From: **Steve Thurston** <thurston.steve@gmail.com>
Date: Wed, May 6, 2009 at 1:25 PM
Subject: Additional testimony Record Hill Wind LLC - noise
To: Beth.Callahan@maine.gov
Cc: "Dr. Dora Anne Mills" <dora.a.mills@maine.gov>, Warren_Brown@umit.maine.edu

Having read the decisions on the Stetson II and Rollins projects I feel the need to submit additional testimony into the record regarding noise. Please acknowledge receipt of this email and the pdf attachment containing exhibits A through H referenced in the following narrative. For their convenience I have CC'd Warren Brown and Dr. Dora Mills. Please confirm with them that their response is needed to complete your findings of fact.

EXHIBIT A

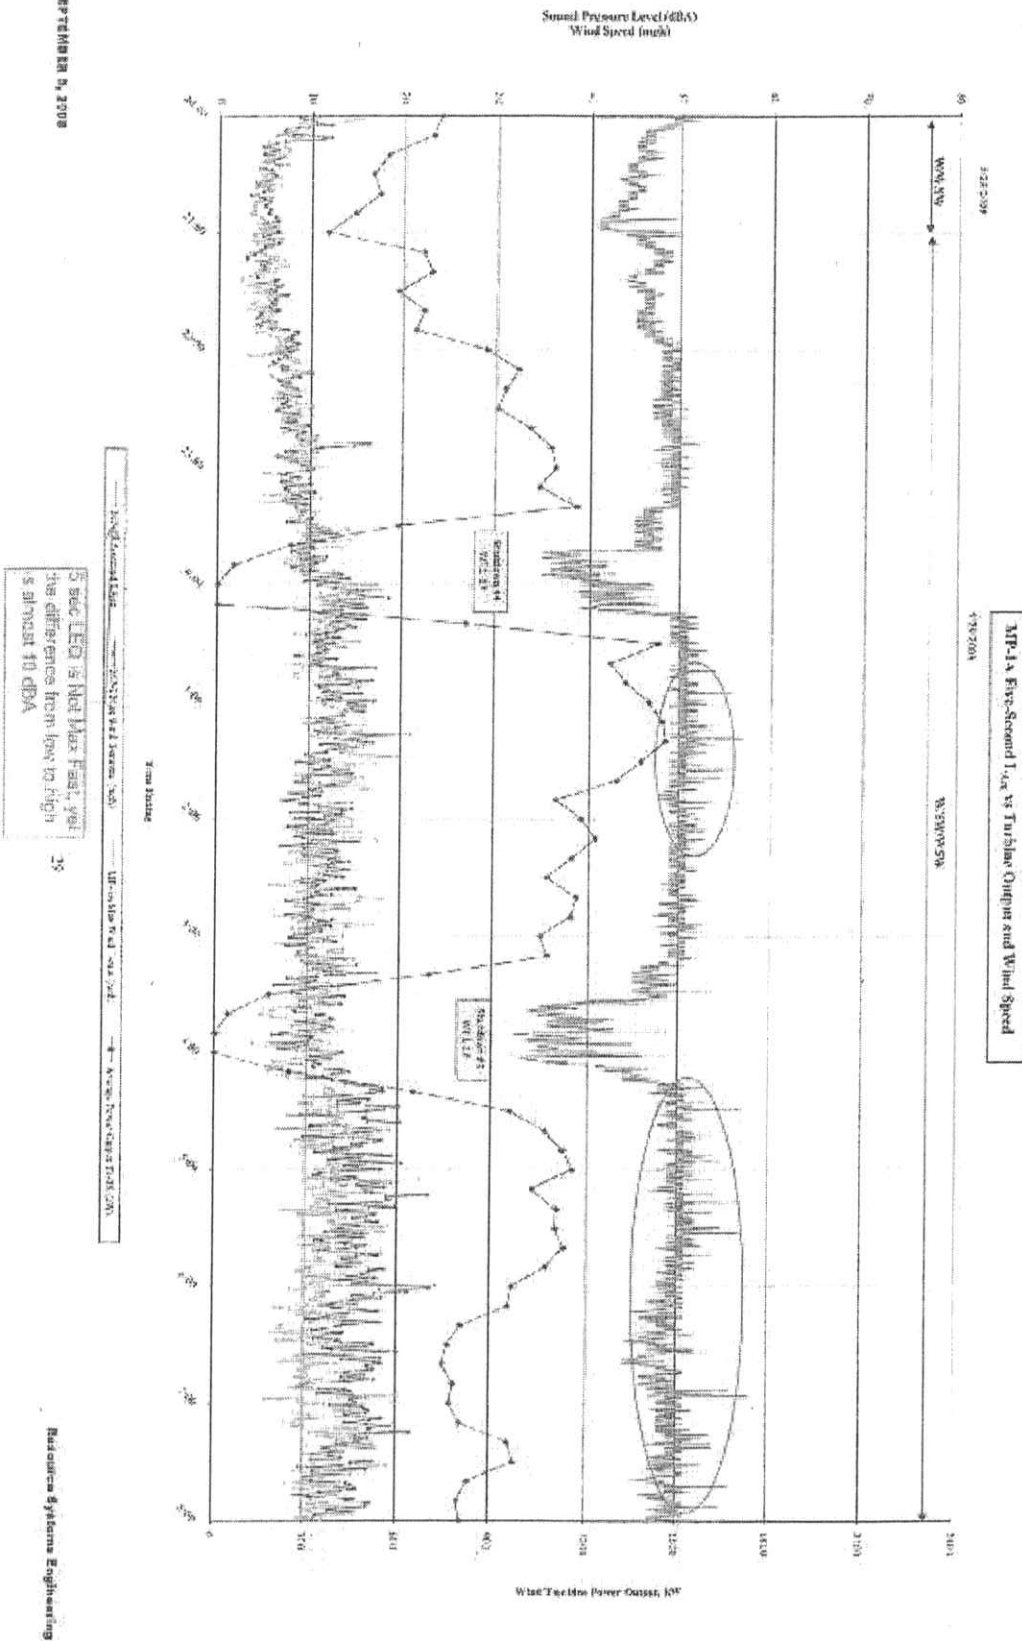
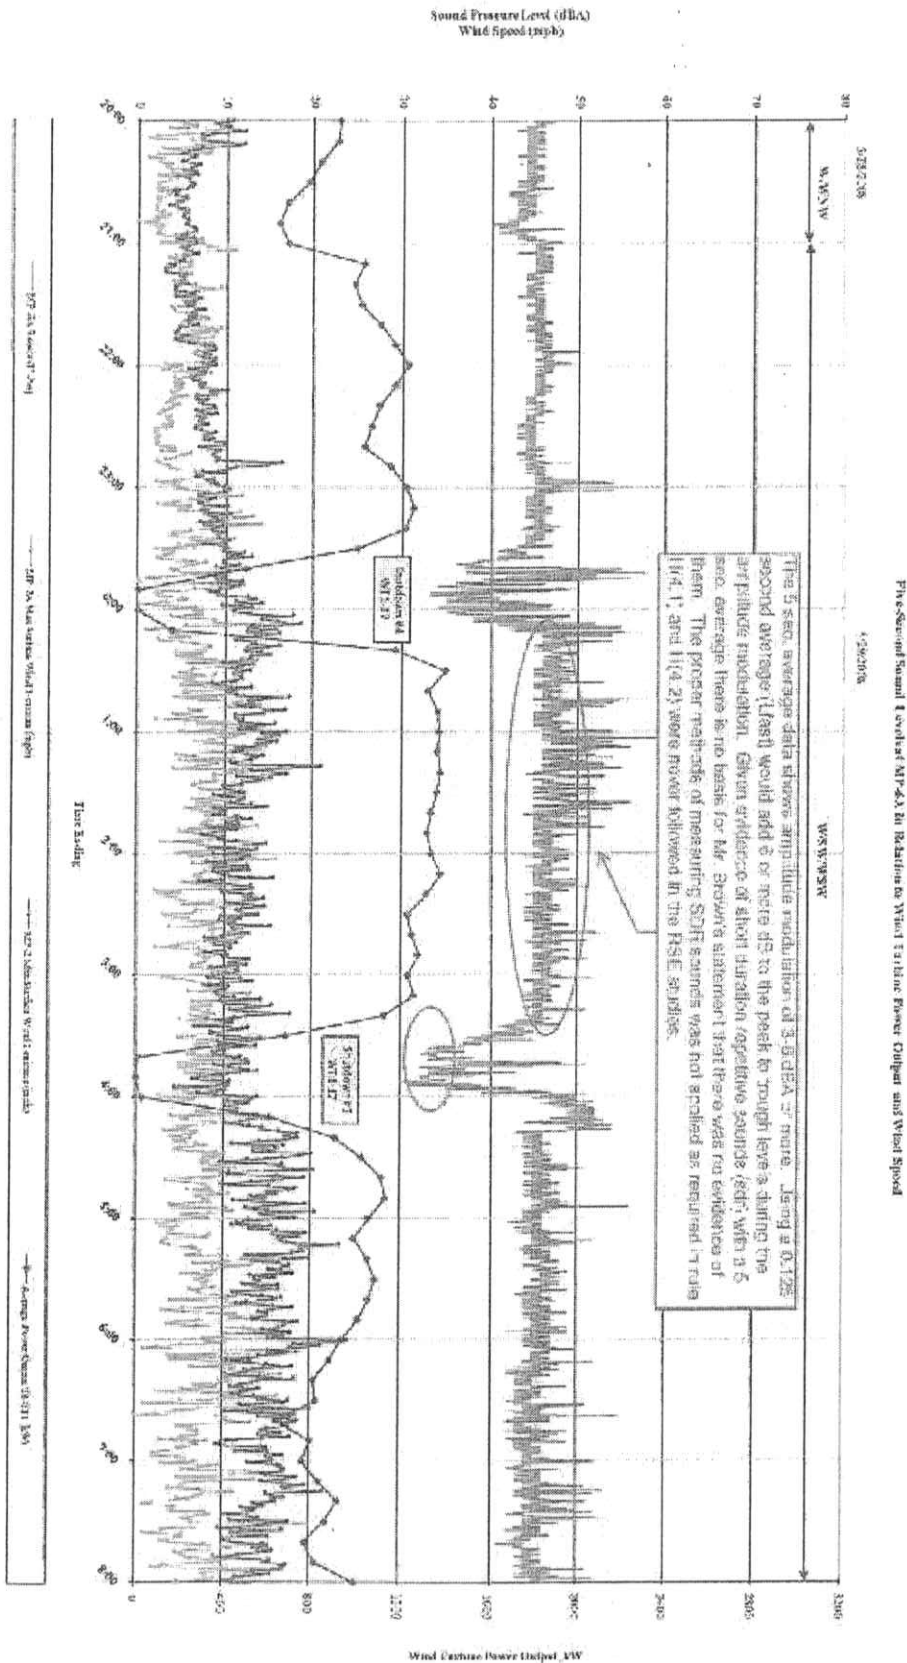
Figure 7-1, (Exhibit A) clearly shows nearly +7 dBA amplitude modulation "peaks" even at 5 second measurement intervals. As Richard James points out in his analysis of the data, a measurement interval of .125 (Lfast) would add 6 dB or more to the peak to trough levels during amplitude modulation. (Exhibit B)

Figure 7-2.

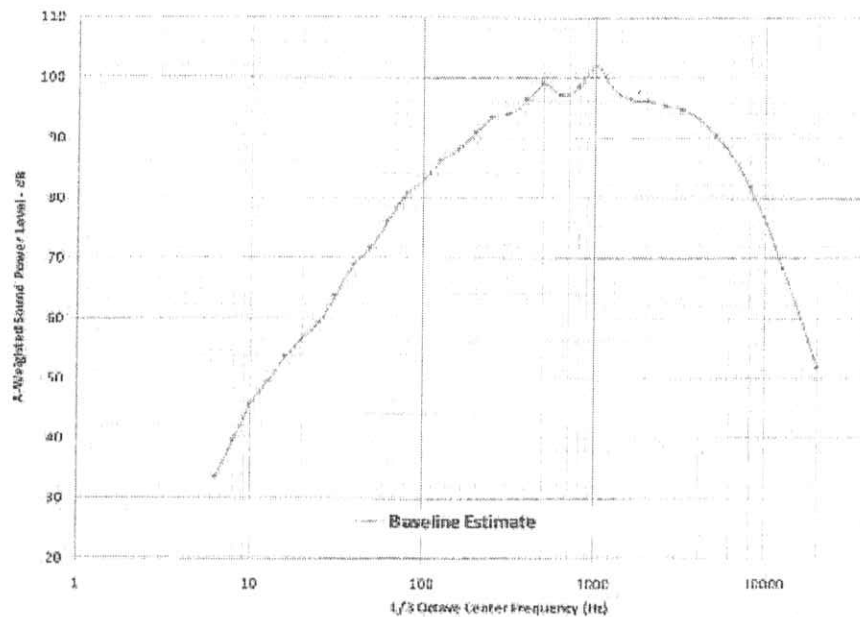
showing sound power levels by frequency band at the various monitoring locations the lower frequencies are much higher (Exhibit C), this despite the fact that the sound emitted by the turbines at the source contains louder noise in the higher frequencies. Table 7-1 Mars Hill noise study Dec. 2008 (Exhibit D)

Figure 4-3. Ambient Hourly Sound Level at MP-2 in Relation to Surface Wind Speed

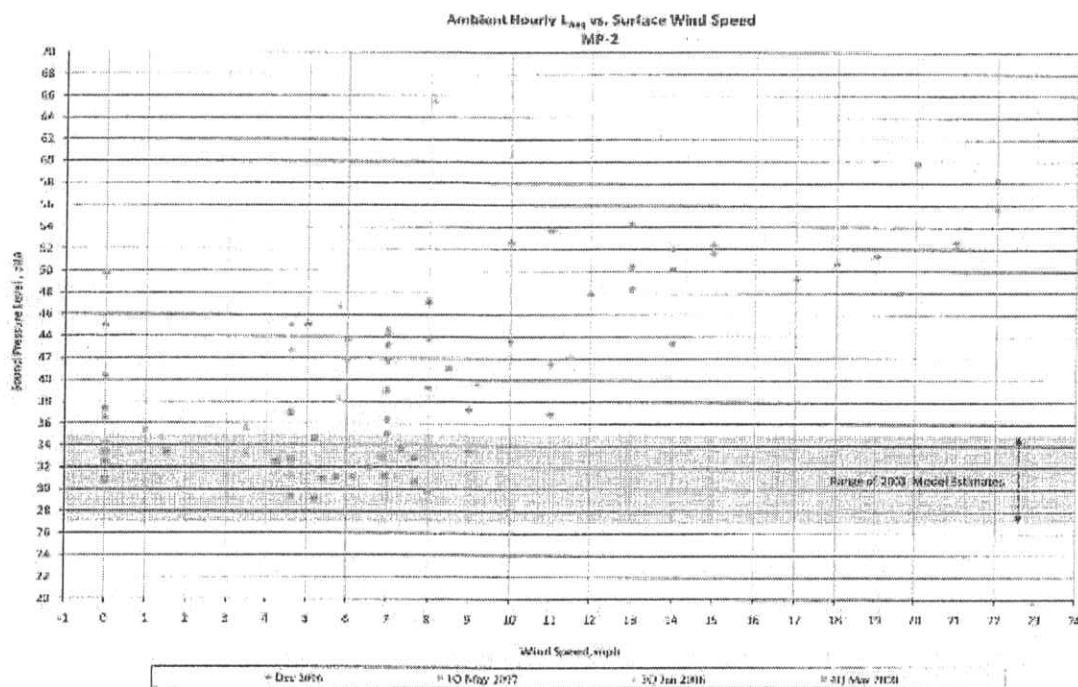
Figure 4-3 (Exhibit E) in the noise study shows turbine noise reaching 50 dBA averaged over one hour when wind speed at the receiver was zero during measurements in Dec. 2006 (blue diamond). Since there was no wind noise, and the narrative indicates "turbine noise prominent", it must be assumed that turbine noise was being measured. Figure 4-3 also shows turbine noise levels reaching 53+ dBA with wind speed below 12 mph, the speed above which useful measurements can no longer be made due to wind noise interference with microphone operation per Maine Noise Regulations. Clearly these measured levels of turbine noise exceed Maine's limits.

Figure 3-11. Correlation between Hourly L_{Aeq} Measurements at MP-2 and Average Power Output of Wind Turbines 10 through 15

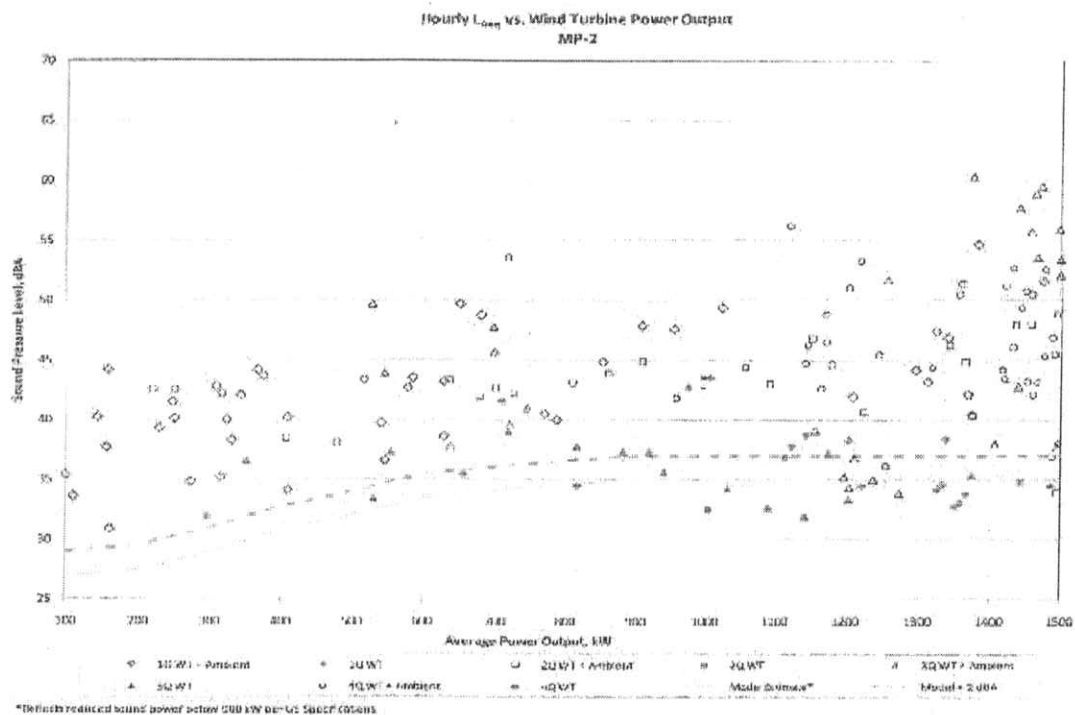
In Figure 3-11 (Exhibit F) the table shows that at a turbine power output of just above 700 kW the noise from the turbines averages 42 dBA during the 1QWT (blue diamond). According to Figure 3-1, the sound level of the GE turbine at this power output is approximately 98.5 dBA. The maximum sound level produced by the GE turbine is 104 dBA, or 5.5 dBA above the measured level of 42 dBA at 700 kW. This places the extrapolated turbine noise at 47.5 dBA, well in excess of Maine's already much too lenient 45 dBA nighttime limit, especially when keeping in mind the dBA measurements discount the low frequency thumping sound which is the source of the majority of wind turbine noise complaints.

Many of the ambient measurements in Figure 3-11 correlate with this assessment. At 1000 kW output, hourly averages of 42.5 and 43 dBA are measured during the 1QWT (blue diamond). According to the GE chart on Figure 3-1 the sound level of the GE turbine at this power output is approximately 100 dBA, 4 dBA below its maximum sound level. Adding 4 dBA to 42.5 and 43 dBA yields turbine sound levels of 46.5 and 47 dBA respectively, further proof of turbine noise levels exceeding Maine's Noise Limits at a distance of 1.1 miles from the turbines, a similar distance to the turbines from homes at Roxbury Pond. Note the model estimate at Mars Hill is approximately 8 dBA lower than these turbine noise measured levels. Although a variance was granted at Mars Hill, there is no justification for granting variances for any other wind energy facilities, including Record Hill Wind LLC when proper mitigation can be required by condition of any permit granted.
